1 **SUBJECT: Economic Risk**

3 **REFERENCE: Chapter 1, Section 1.4.2.4 Annual Planning Cycle at 20:14-21:6**

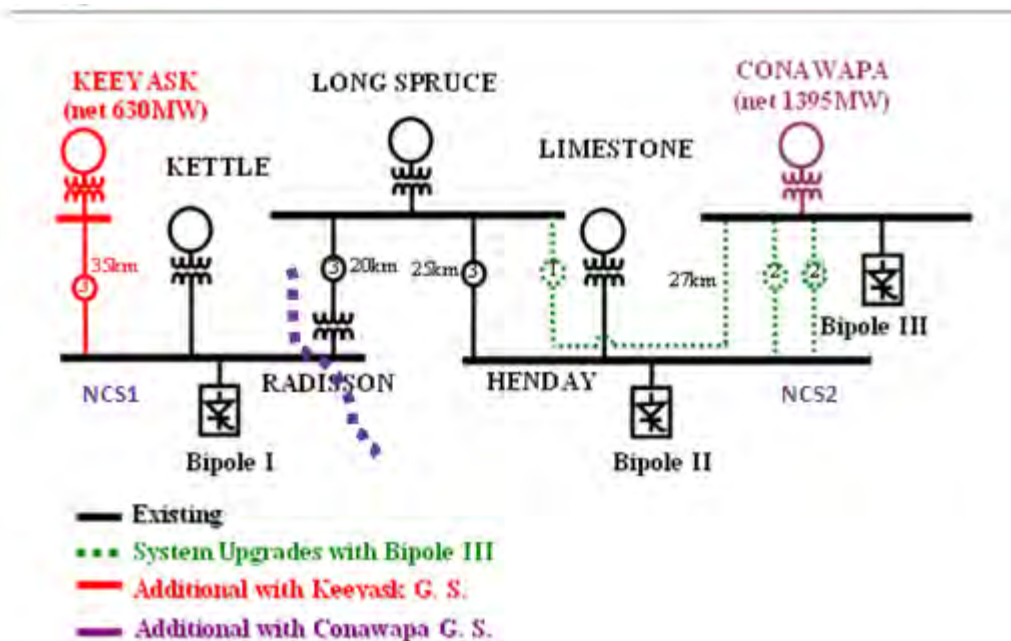
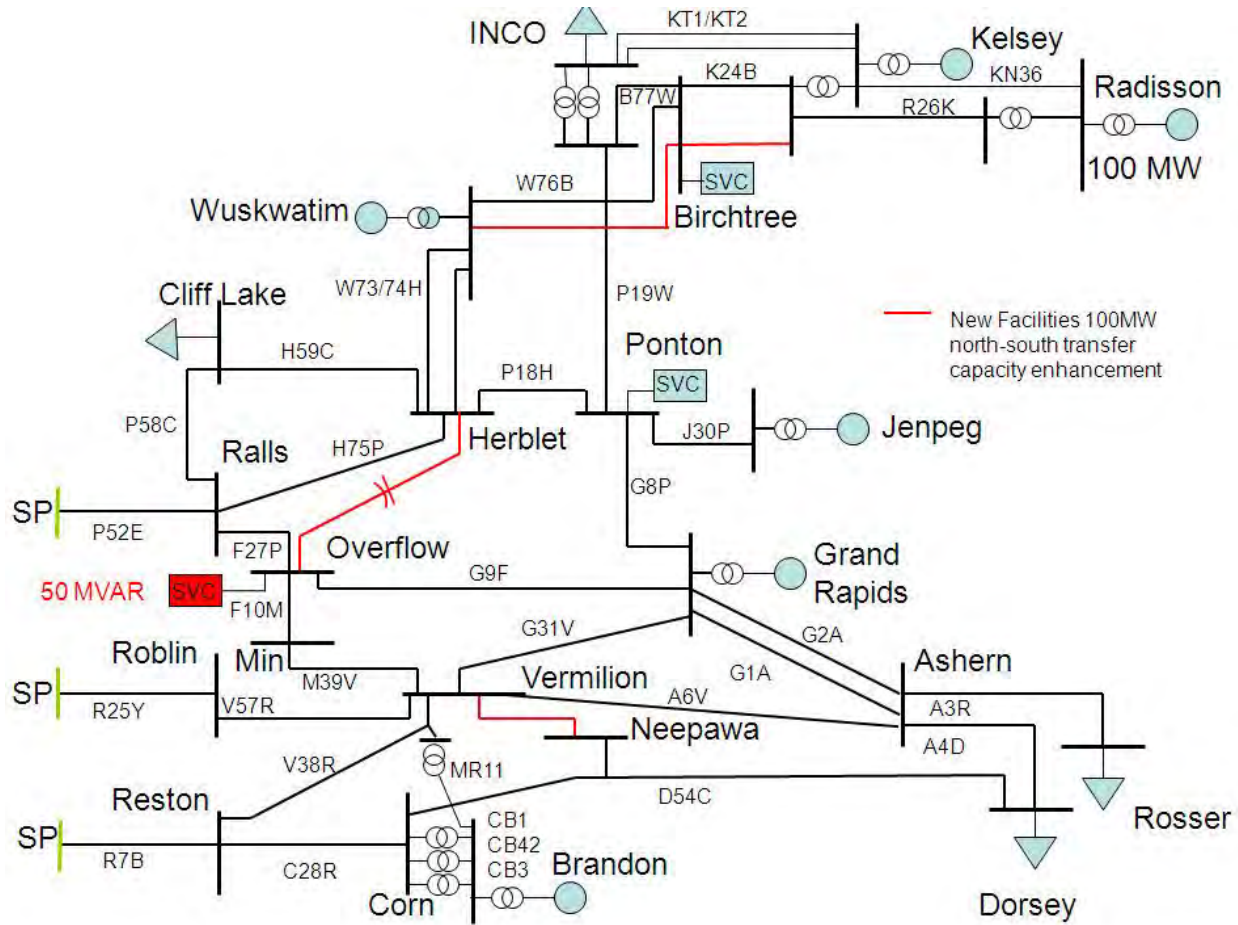
7 Referring to the descriptions of the transmission projects relating to each of Keeyask and
8 Conawapa as contained in Chapter 2, please provide one-line or geographic diagrams
9 illustrating the transmission lines in the northern Nelson area today, after construction of
10 Bipole III, and after construction of the North-South Transmission Project.

13 The conceptual single line diagrams of the northern collector system upgrades and northern ac
14 system upgrades for the Manitoba Hydro preferred development plan are shown below.

23 Figure 1 – Forecast of Manitoba RGDP (2012 Economic Outlook)

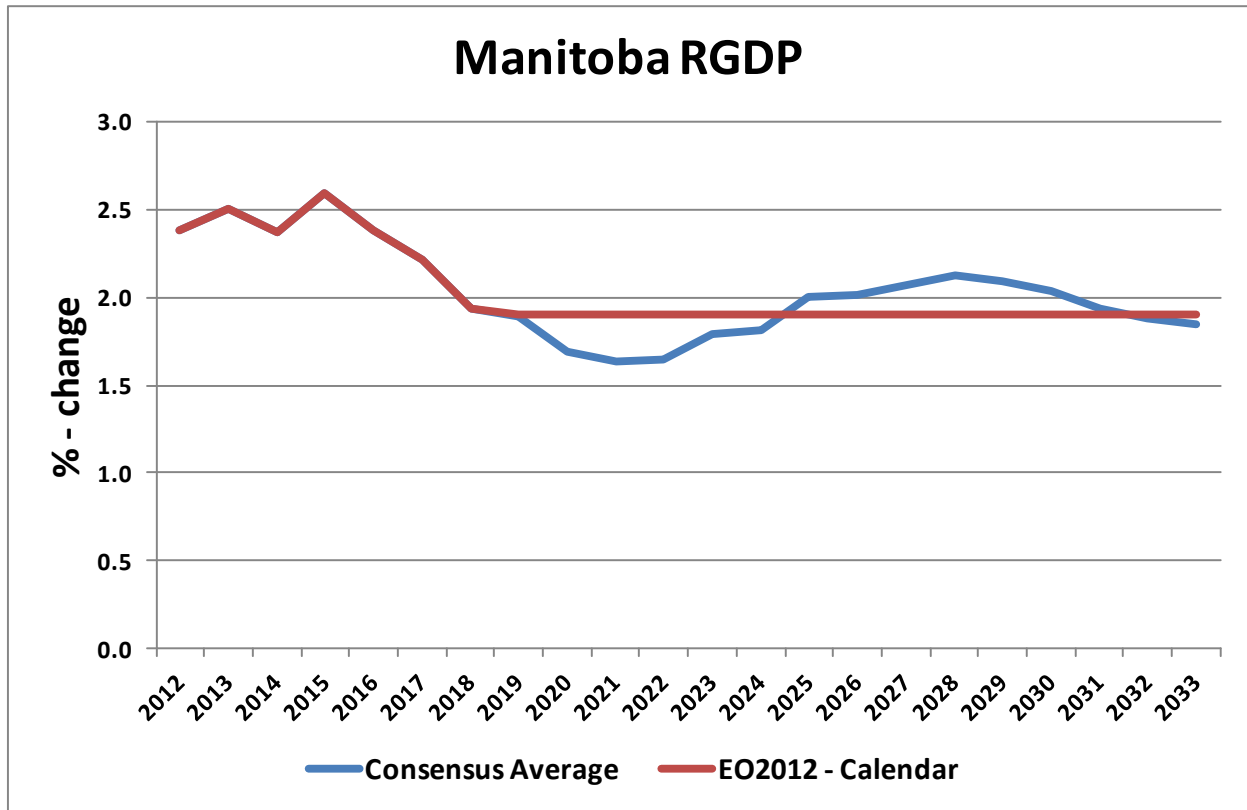
14 Please explain why the Spatial Economics projections have been given less weight in the
15 determination of long-term Manitoba RGDP.

18 The forecast of Manitoba RGDP is derived from the average of the consensus survey using the
19 sources as listed in Table 1 in the response to MMF/MH I-069.
